कार्यालय प्रभागीय वनाधिकारी, बागेश्वर वन प्रभाग बागेश्वर

जनपद बागेश्वर में झोपड़ा शिखर बास्ती मोटर मार्ग (प्रस्ताव संख्या 15673/2015)।

ऑन लाईन लगाई गई आपत्ति के कम में।

डिजिटल मैप – जनपद बागेश्वर के अन्तर्गत झोपड़ा –शिखर – वास्ती
मोटर मार्ग के विस्तार हेतु

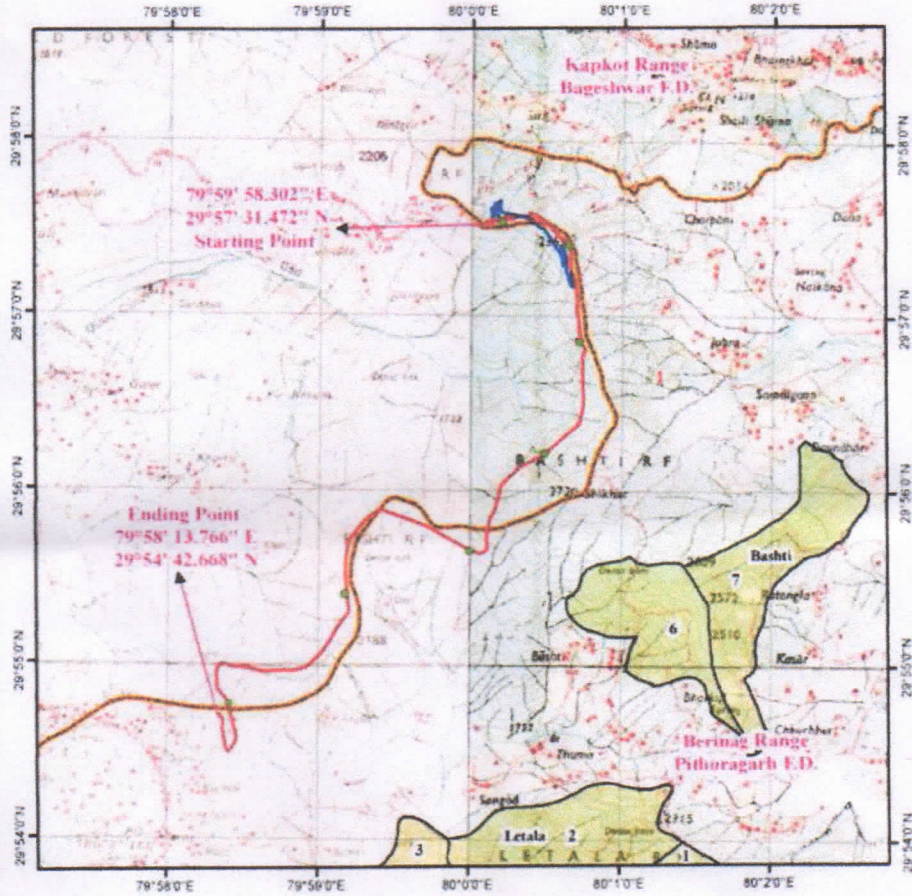
बिन्दु सं 4	Component wise break up is incomplete as the area designated for muck disposal is not shown in component wise break up in Part I.	Component wise break up is now provided in Part I.
बिन्दु सं 5	The details pertaining to alternate examined is not provided in Part I neither the required Map showing the alternate alignment examined is uploaded in the designated column in Part I.	Map showing the alternate alignment examined is provided and uploaded in Part I.
बिन्दु सं 6	Employment generation details are not furnished in Part I.	मोटर मार्ग की कुल लम्बाई-12.00किमी०, निर्माण के दौरान उत्पादित श्रमिक दिवस - $30 \times 30 \times 18 = 16200$ Mandays. निर्माण पूर्ण होने के पश्चात स्थाई श्रमिकों की सं 4 $4 \times 12 = 48$ permanent/regular employment. Total employment generated during road construction will be 16200 Mandays and 48 permanent/regular employment(it has been enclosed in the Part I at E column)

जियोरेफरेन्स मैप - जनपद बागेश्वर के अन्तर्गत झोपड़ा - शिखर - वास्ती
मोटर मार्ग के विस्तार हेतु

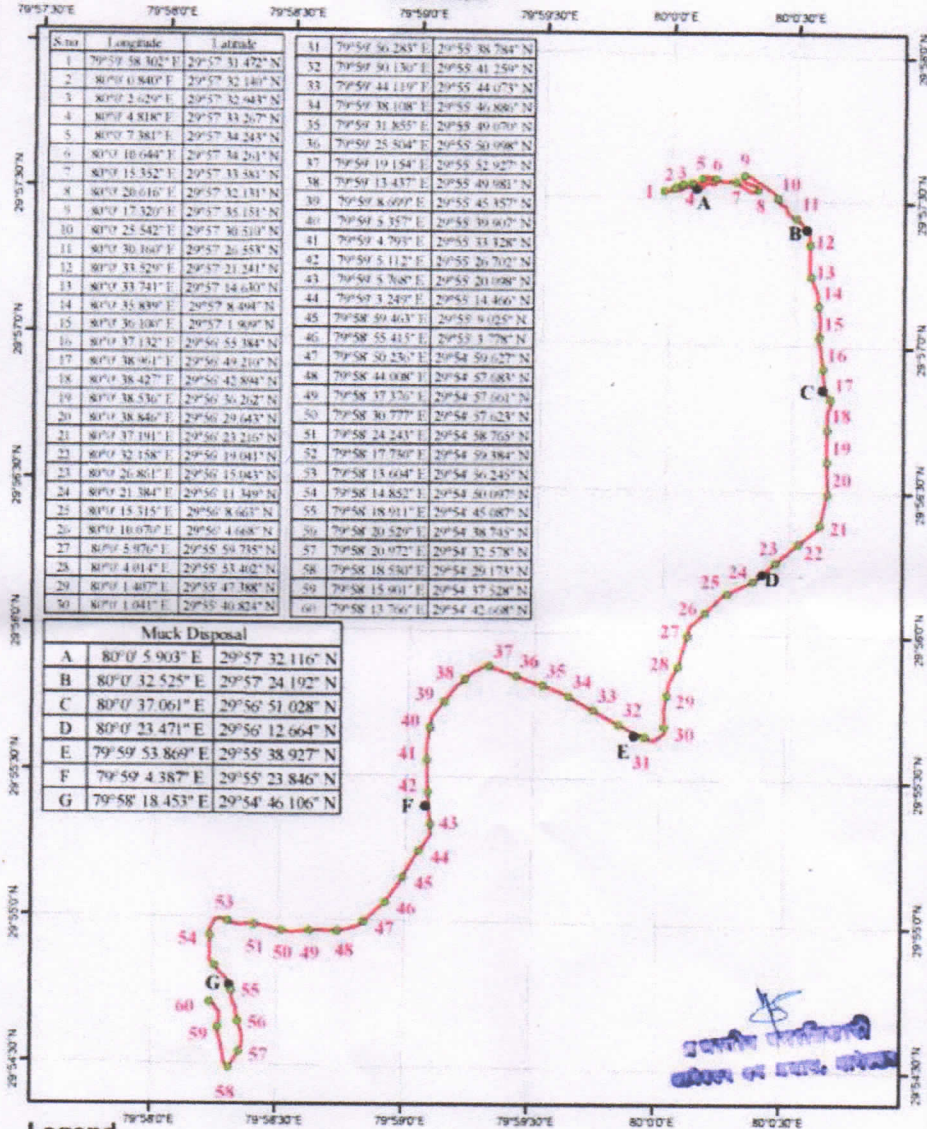
बिन्दु सं 7	Village level committee proceeding provided for only one village though as per details furnished with the hard copy that 6 villages are benefited with the road. The State Govt. may clarify that does the road pass through the boundary of other 5 villages or not and if required the proceedings for other gram sabhas may also be furnished.	In proposed road alignment passes through only one gram sabha named Basti and other 5 villages named Jhopra, Kasnaula, Badkula, Bhagour, Dwayari one basically sub villages/tok of Basti village. Now village wise break up is corrected and uploaded.
बिन्दु सं 8	GIS software generated geo-referenced Map showing digitally marked Geo-coordinates for 200-300mtr along the alignment including all turns of the proposed road may be uploaded in designated column in Part I. the google Map will not accepted for the purpose.	Now required GPS marked digitally on Geo-referenced Map is provided and uploaded in Part I.

जिल्हाकार्यालय मध्य - जलनद बाजारपेठे क अन्तर्गत झापडा -शेखर - वायना गावस मधील क पक्काई हेतु
 चयनित क्षतिपूर्क वृक्षारोपण स्थल

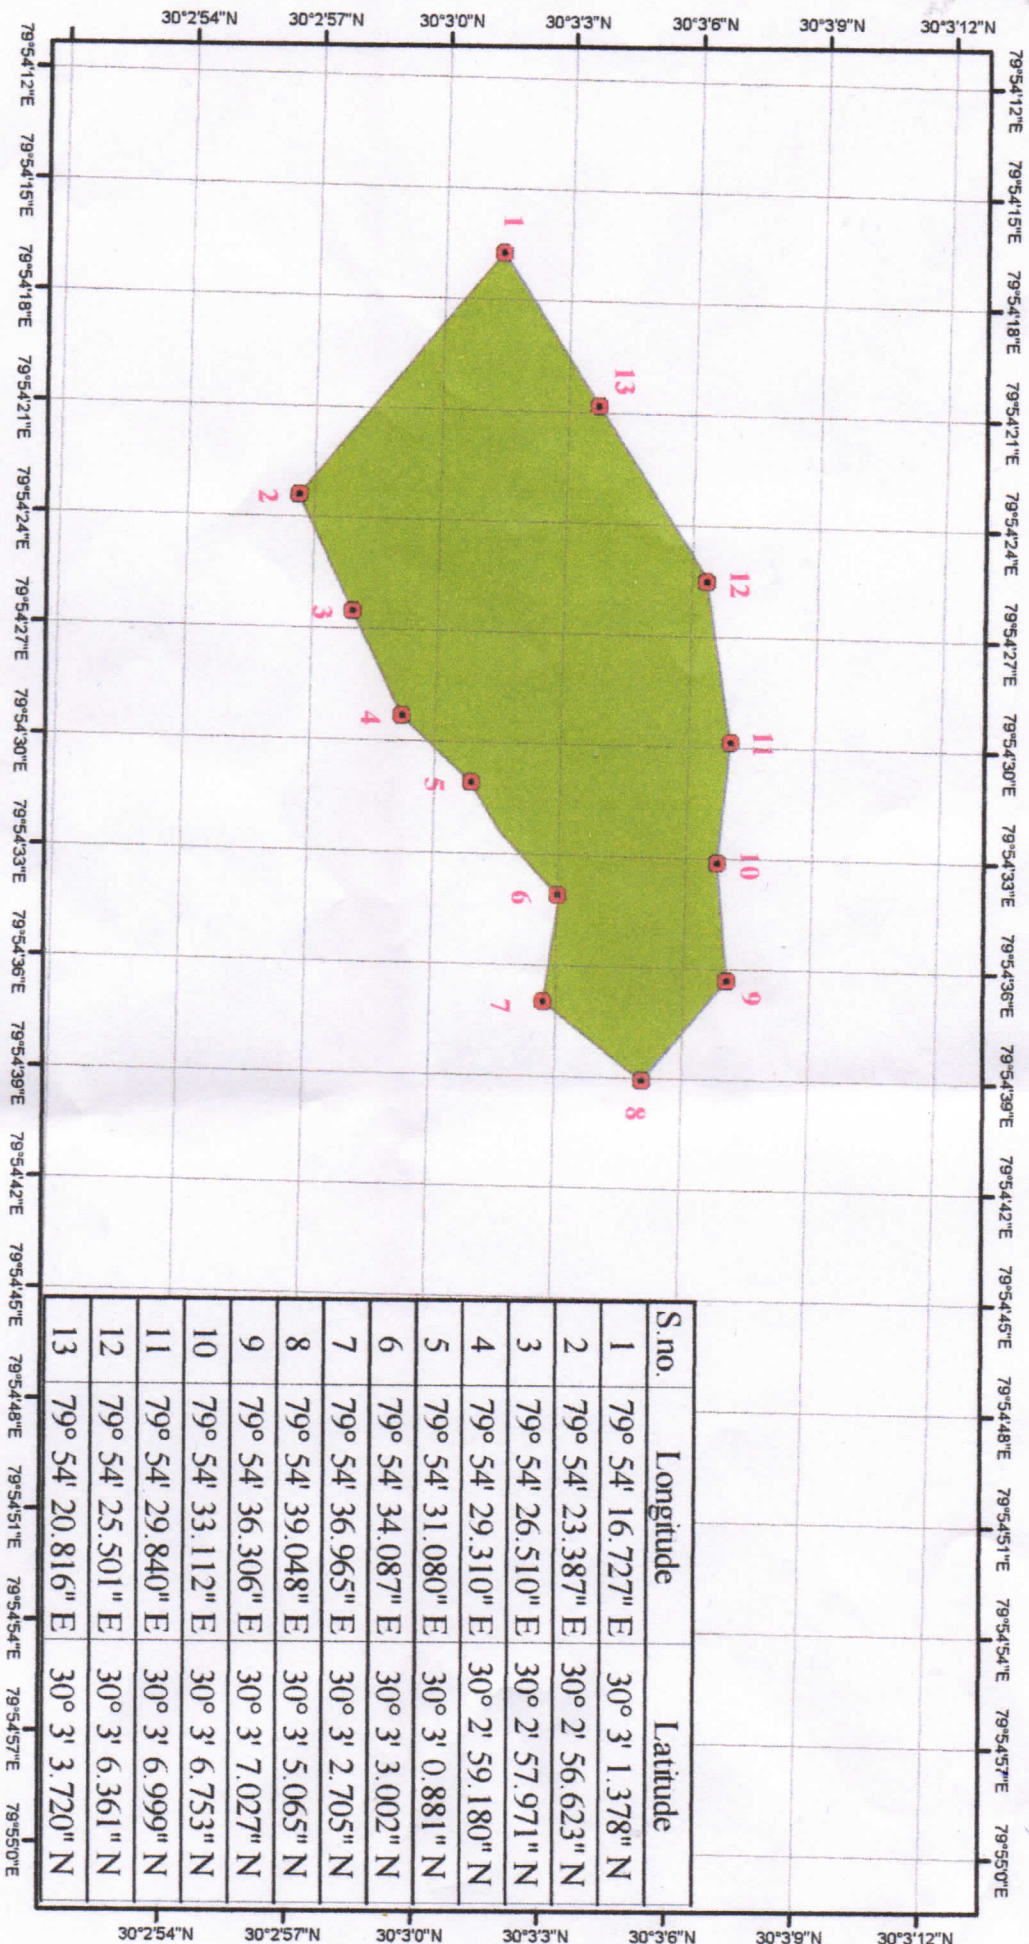
बिन्दु सं 9	GIS software generated geo-referenced Map showing digitally marked Geo-coordinates of all corners of the area proposed for CA in polygon/closed shape file may be uploaded in the	GIS software generated geo-referenced Map showing digitally marked geo-coordinates of all corners of the area proposed for CA in polygon/closed shape file is provided and uploaded in Part I.

designated place in Part I. the google map will not be accepted for the purpose.	
बिन्दु स0 10	In the DSS analysis the area marked for CA shows presence of 3ha area out of total area 9.974 ha in moderately dense forest which is not suitable for CA. the State Govt. may propose this 3ha area at some other suitable place and revise the KML, Geo-referenced digital Map showing coordinates of all corners accordingly, and upload same in the designated place in Part I.	प्रस्ताव विभाग एवं प्रभागीय वनाधिकारी द्वारा वृक्षारोपण स्थल का निरीक्षण का लिया गया है। प्रमाण पत्र संलग्न कर प्रेषित किया जा रहा है तथा पार्ट 1 में अपलोड कर दिया गया है ।
बिन्दु स0 11	The administrative approval provided in the hard copy is not clearly shown the length of the road approved. The State Govt. may clarify that the administrative and financial approval is available for the total length of the road proposed or not and if required the visible copy of approval may be provided in this office.	There are three different G.O s for whole road first one of 2 km under State sector G.O. no. 122/PWD-2/2004-4(Tech)/2004 dated 06-02-2004 and second one of 5.00 km under State sector G.O. n0. 784/III(2)/08-42(MLA)/07 dated 20-03-2008 and third one of 6.00 km under district sector G.O.no. 929/district sector 2010-11 dated 17-08-2010 this the road length approved about 13km but after completion of preliminary survey length of road coe out 12.00 km . the finanacial and administrative approval of this road are attached with proposal.
